ITEM #11 - PRELIMINARY PLAT Fort Raymond Subdivision Replat Number 7

KPB File No.	2023-107
Plat Committee Meeting:	December 11, 2023
Applicant / Owner:	City of Seward / Seward, AK
Surveyor:	Stacy Wessel / AK Lands Land Surveying
General Location:	City of Seward

STAFF REPORT

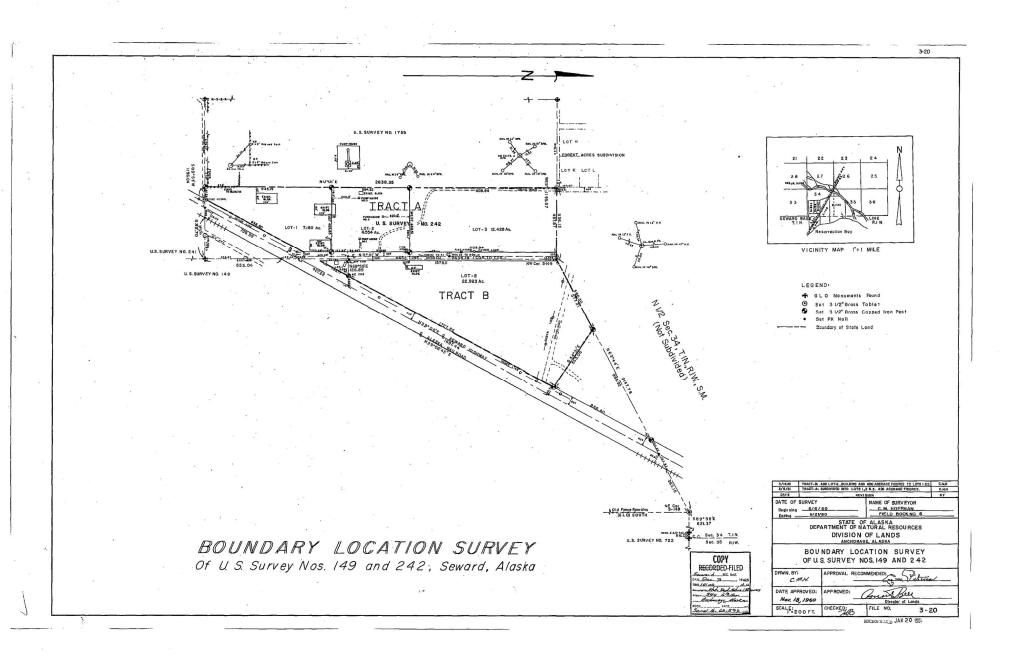
There is a 25' utility easement on the west line of the lots from the previous plats shown. There is a 30' utility easement on the east line of the lots from previous plats shown. There is a 100' utility easement crossing Lot 10A-2 shown from the previous plats. All three of these easements should include in their labels the subdivision indication they were created from.

There is an easement listed in the Quit Claim Deed Bk 318 PG 5 as ADL 26281 – Power Line Easement 30 feet in width, filed at Serial 2019-000117-0 that needs to be shown on the drawing.

Add north arrow to vicinity map

Depict the city limits

Relabel Fourth Ave to Third Ave.

First Ave should be Vista Ave it appears

Previous parcel description is not need within the lot and can be removed. If to be left, change the text to italic.

Parcel to the east needs changed to Lot 3

Parcel to the northeast need the lot and plat label changed as there has been a new subdivision recorded for it.

Zoning labels are not needed on the lots unless required by the City of Seward.

- Is Certificate of Acceptance needed on the plat. Staff did not see any public access easements, ROW or other public areas not already public owned, please verify need and list in Certificate if found.
- Add the date of December 11, 2023 to the Plat Approval.
